Addendum 1
Solicitation 20-99323
2020 Street Preservation Project

This addendum serves to notify all bidders of the following changes to the solicitation documents:

Duluth 2020 Street Preservation

SHEET NO. 11 OF 247

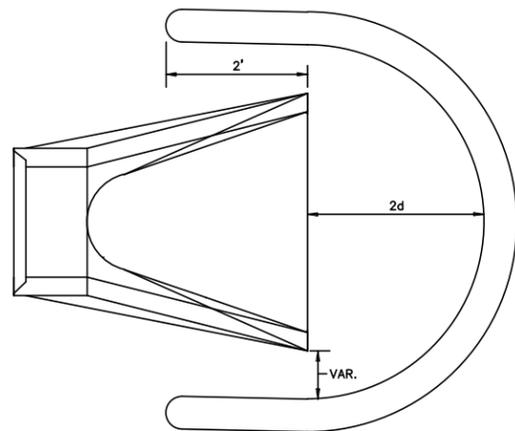
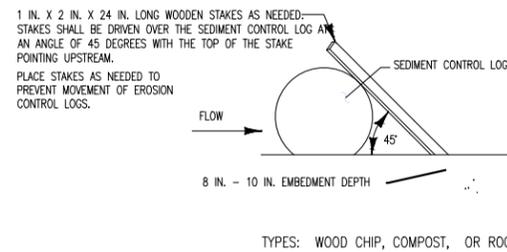
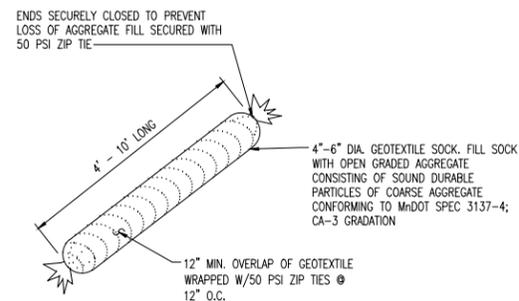
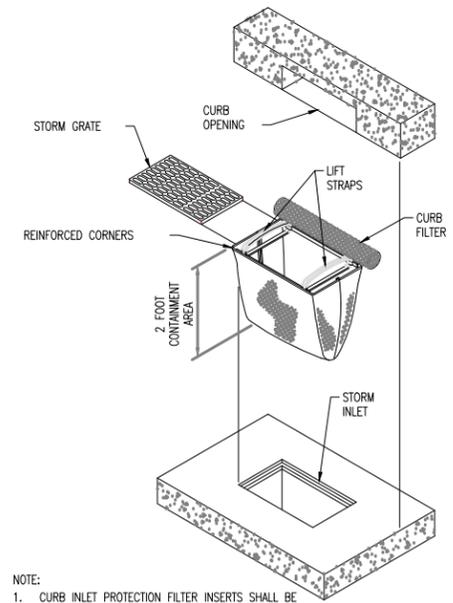
- b. See attached Sheet 10 which has been updated for notes related to the addition of the compactor hours.
 - c. See attached Sheet 11 for changes in detail references in the notes on that sheet.

DRAWN BY: CJL
PAVING, DITCHING AND MARKINGS DETAILS
SHEET NO. 12 OF 247

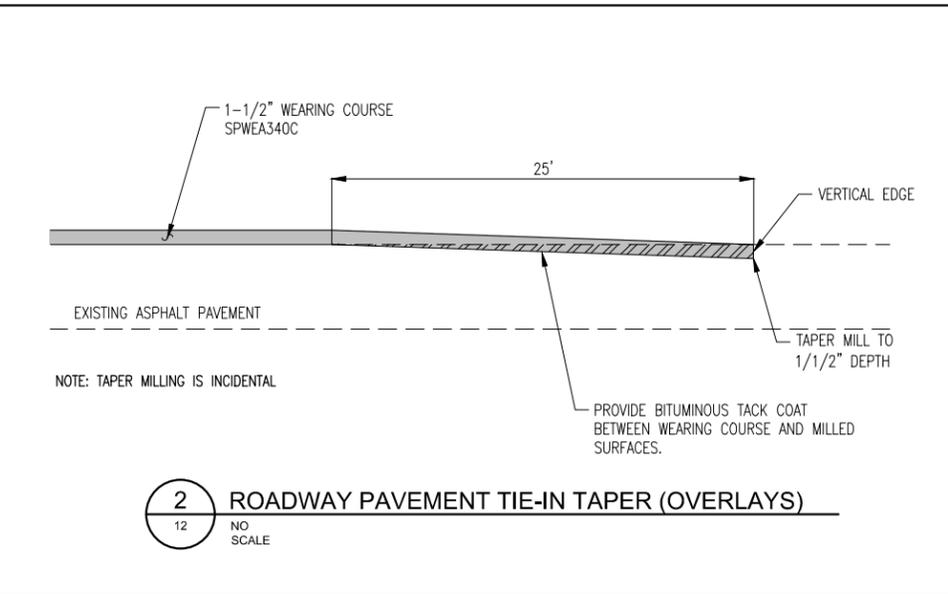
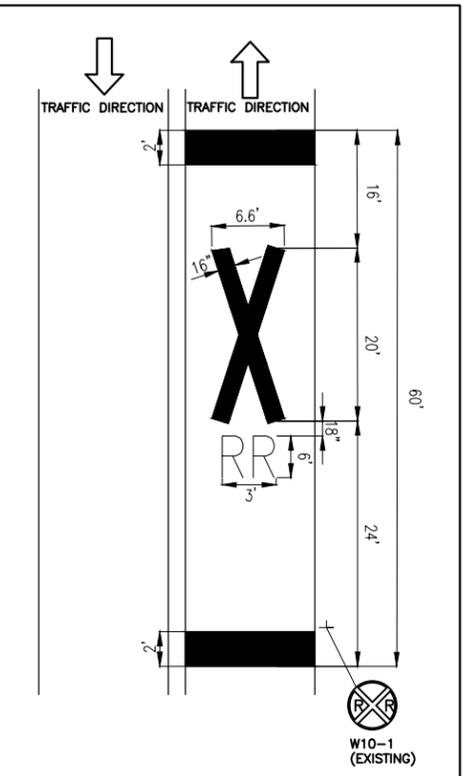
- d. See attached Sheet 12 for changes in construction details, adding detail drawing (7/12) showing a typical section for ditch to be constructed under Item 2105.603 Construct Drainage Ditch (LF). Note 15 on Sheet 10 also describes what is included under this pay item.

- ALL SIDE STREETS AND BEGINNING AND ENDING TIE-INS TO EXISTING ON RECLAIMS AND OVERLAYS SHALL BE TAPER MILLED AT A DISTANCE REQUIRED TO MAKE A SMOOTH TRANSITION AT A DESIGN SPEED OF 30 MPH SEE DETAILS 1 AND 2 ON SHEET 12. ALL ROADWAY TAPER MILLS AND SAWING OF JOINTS SHALL BE INCIDENTAL.
